Project	IEEE 802.16 Broadband Wireless Access Working Group < http://ieee802.org/16 >	
Title	Resource reuse and interference management mechanism	
Date Submitted	2006-11-07	
Source(s)	Wei-Peng Chen Chenxi Zhu Ching-Fong Su Jonathan Agre	wei-peng.chen@us.fujitsu.com chenxi.zhu@us.fujitsu.com chingfong.su@us.fujitsu.com jonathan.agre@us.fujitsu.com
	Fujitsu Laboratories of America 1240 E. Arques Avenue, M/S 345, Sunnyvale, CA 95051, USA	Voice: +1 408-530-4622
Re:	IEEE 802.16j-06/027: "Call for Technical Proposals regarding IEEE Project P802.16j"	
Abstract	Resource reuse is an essential feature in multihop relay networks to enhance the system throughput. More aggressive resource reuse could lead to performance improvement. Nevertheless, interference between radios sharing the same resource needs to be well regulated and controlled to avoid system performance degradation. In this contribution we propose a framework and define messages to support adaptive interfere management scheme.

Resource reuse and interference management mechanism

Wei-Peng Chen, Chenxi Zhu, Ching-Fong Su, Jonathan Agre
 Fujitsu Laboratories of America

Figure 130j An example of resource allocation for RS cell.

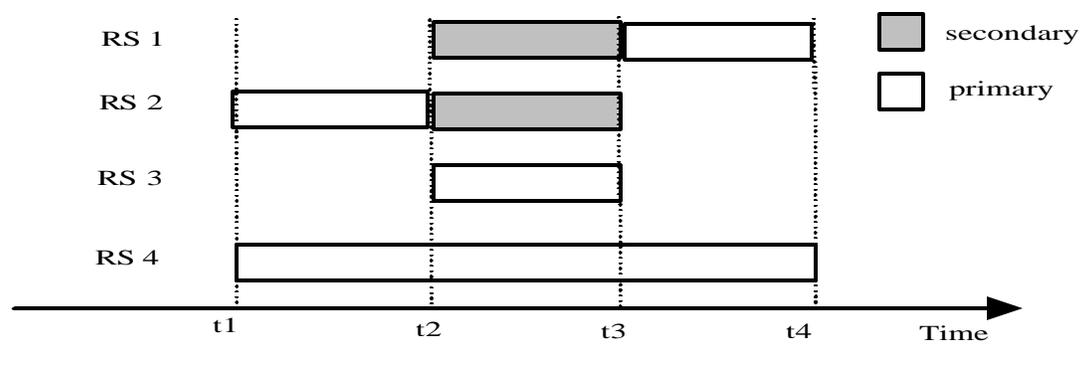
Insert a new subclause 6.3.27.2:

6.3.27.2 Resource reuse allocation and calibration for multihop relay networks

Each RS is instructed by MR-BS about the resource available for RS cell communication. The resource for each RS cell may differ to avoid interference, but may also overlap to allow resource reuse. An example of resource allocation for RS is shown in Figure 130j. For each piece of resource, each RS is designated as either a primary user or secondary user. The information of indicating the primary user or secondary user is defined in MR_DL_Allocation_IE (8.4.5.3.28) and MR_UL_Allocation_IE (8.4.5.3.29). When the bit “Secondary usage indication” is enabled, the receiver of MR_DL_Allocation_IE or MR_UL_Allocation_IE shall be the secondary user and shall give the priority of transmission to the primary user if interference is detected.
